COMPOSITE OF EXPANDORAM II MODIFICATIONS

TECHNICAL BULLETIN NO. 105

EXPANDORAM II

Extensive field usage and further R&D in our engineering department has determined that the ExpandoRAM II could hang up in Wait State Refresh cycles under certain conditions. The modifications delineated below solve this problem:

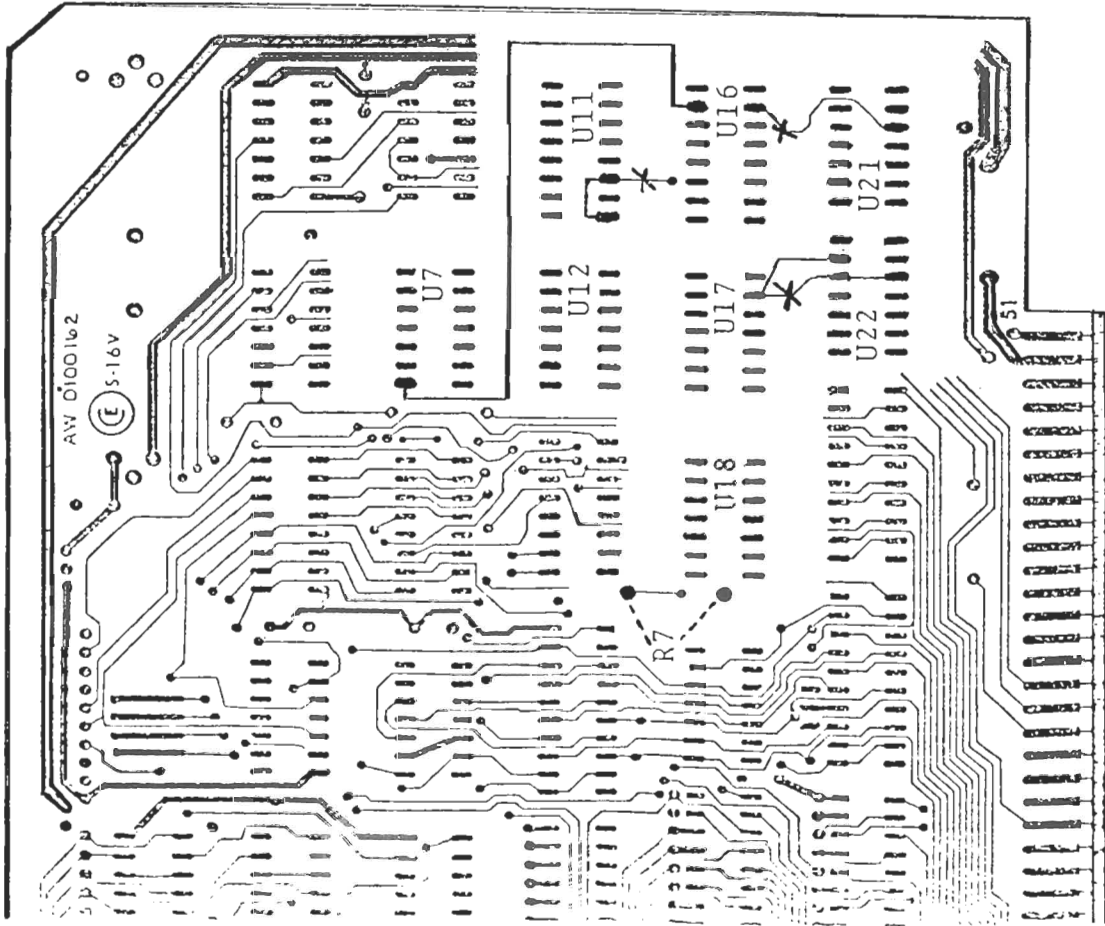
To Identify Problem:

1. Change U6 from 74LS74 (Low-Power Schottky) to 74S74 (Schottky).
2. Change R7 from 10K ohms to 20K ohms.
3. Using the diagram on the back of this page, rework boards to change WAIT STATE REFRESH TIME to leading edge of $\phi 1$.
 - a. Cut etch from U11-14 to U16-7
 - b. Cut etch from U16-10 to U21-10
 - c. Cut etch from U17-9 to U22-5
 - d. Connect an insulated jumper wire from U11-14 to U11-16
 - e. Connect an insulated jumper wire from U7-1 to U16-7
 - f. Connect an insulated jumper wire from U17-9 to U22-6

1. Examine diagram to left and locate the three traces marked with an 'X'. Double check to ensure that you have the correct traces and then cut them with a sharp knife. Make the cut deep and 'v' shaped to make sure that the connection is broken.

2. Locate U7; note the only connection and follow it to U16. Using an insulated wire, complete the connection as shown.
3. Locate U11; note the only connection is a jumper between two pins on U11. Using an insulated wire, complete the connection as shown.

4. Locate U17; note the new connection and follow it to U22. Using an insulated wire, complete the connection as shown.
5. Locate R7 to the left of U18; its solder points are indicated by dotted lines. Remove R7 and replace it with the 20K Ohm resistor provided.

6. Turn your PC board over and locate U6. With a small flat blade screw driver, gently and slowly pry U6 out of its socket. Note the way it is placed in the socket. Using the replacement IC provided, line up all pins with the socket. Be sure that the replacement IC is in the correct position and then push it into the socket firmly. Examine closely making sure no pins were bent.
